Product Change Notice (PCN)

PCN Number: **PCN-0456757R**

Product(s) Affected: ***SJ1-253X-SMT-TR Series (SJ1-2533-SMT-TR, SJ1-2534-SMT-TR & SJ1-2535-SMT-TR)***

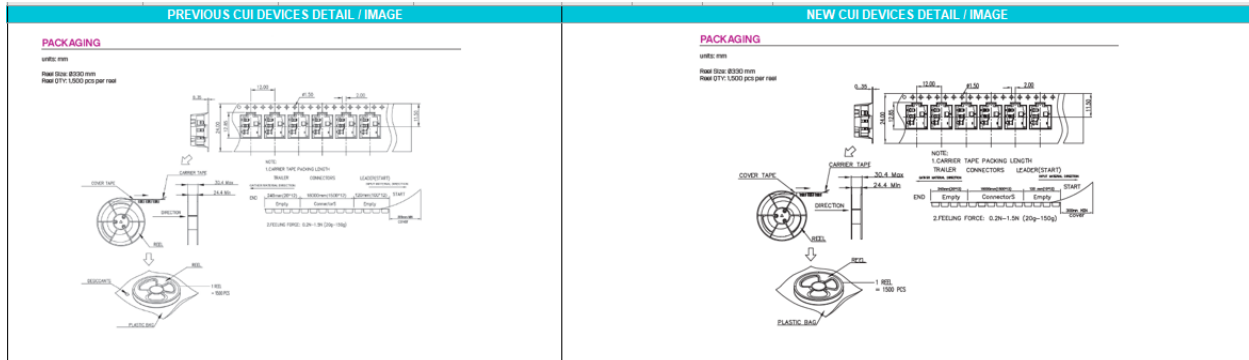
Description of Change: ***New Factory Location. Product re-engineered for improved manufacturability and production yield. See image below for reference and check CUI Devices website for updated drawing. Cosmetic differences may be visible and not affect the form fit and function of the product.***

DESCRIPTION	MATERIAL	PLATING/COLOR																																																																																													
terminal 1	copper alloy	gold																																																																																													
terminal 2	copper alloy	gold																																																																																													
terminal 3	copper alloy	gold																																																																																													
terminal 4	copper alloy	gold																																																																																													
terminal 5	copper alloy	gold																																																																																													
housing	PAST UL94V-0	black																																																																																													
DESCRIPTION	MATERIAL	PLATING/COLOR

terminal 1	copper alloy t=0.20	gold over nickel																																																																																													
terminal 2	copper alloy t=0.20	gold over nickel																																																																																													
terminal 3	copper alloy t=0.20	gold over nickel																																																																																													
terminal 4	copper alloy t=0.20	gold over nickel																																																																																													
terminal 5	copper alloy t=0.20	gold over nickel																																																																																													
housing	PA10T UL94V-0	black																																																																																													
<p>SOLDERABILITY</p> <table border="1"> <thead> <tr> <th>parameter</th> <th>conditions/description</th> <th>min</th> <th>typ</th> <th>max</th> <th>units</th> </tr> </thead> <tbody> <tr> <td>lead storage</td> <td>10-30°C, <70% humidity</td> <td></td> <td></td> <td></td> <td>°C</td> </tr> <tr> <td>reflow soldering¹</td> <td>see reflow profile</td> <td>255</td> <td>260</td> <td></td> <td>°C</td> </tr> <tr> <td>drying conditions²</td> <td>parts to reflow: soak at 100°C for 4 hours parts removed from reflow: soak at 100°C for 4 hours</td> <td></td> <td></td> <td></td> <td></td> </tr> </tbody> </table> <p>Notes: 1. CUI Devices recommends to solder within 70 hours from leaving vacuum packaging at a temperature 100°C & relative humidity 100%. 2. When reworking, see 30 by 3000 hours.</p> <p>* Time 25°C to Peak Temp. --- 8 Minutes Max. * Time within 5°C of Actual Peak Temp. --- 10-40 Seconds</p>						parameter	conditions/description	min	typ	max	units	lead storage	10-30°C, <70% humidity				°C	reflow soldering ¹	see reflow profile	255	260		°C	drying conditions ²	parts to reflow: soak at 100°C for 4 hours parts removed from reflow: soak at 100°C for 4 hours					<p>SOLDERABILITY</p> <table border="1"> <thead> <tr> <th>parameter</th> <th>conditions/description</th> <th>min</th> <th>typ</th> <th>max</th> <th>units</th> </tr> </thead> <tbody> <tr> <td>lead storage</td> <td>5-25°C, 20-75% humidity</td> <td></td> <td></td> <td></td> <td>°C</td> </tr> <tr> <td>reflow soldering</td> <td>see reflow profile</td> <td>255</td> <td>260</td> <td></td> <td>°C</td> </tr> </tbody> </table> <p>Notes: 1. CUI Devices recommends usage of the product within 24 hours after 100% to opened. After 24 hours, CUI Devices recommends drying the parts prior to use.</p>						parameter	conditions/description	min	typ	max	units	lead storage	5-25°C, 20-75% humidity				°C	reflow soldering	see reflow profile	255	260		°C

parameter	conditions/description	min	typ	max	units																																																																																										
lead storage	10-30°C, <70% humidity				°C																																																																																										
reflow soldering ¹	see reflow profile	255	260		°C																																																																																										
drying conditions ²	parts to reflow: soak at 100°C for 4 hours parts removed from reflow: soak at 100°C for 4 hours																																																																																														
parameter	conditions/description	min	typ	max	units																																																																																										
lead storage	5-25°C, 20-75% humidity				°C																																																																																										
reflow soldering	see reflow profile	255	260		°C
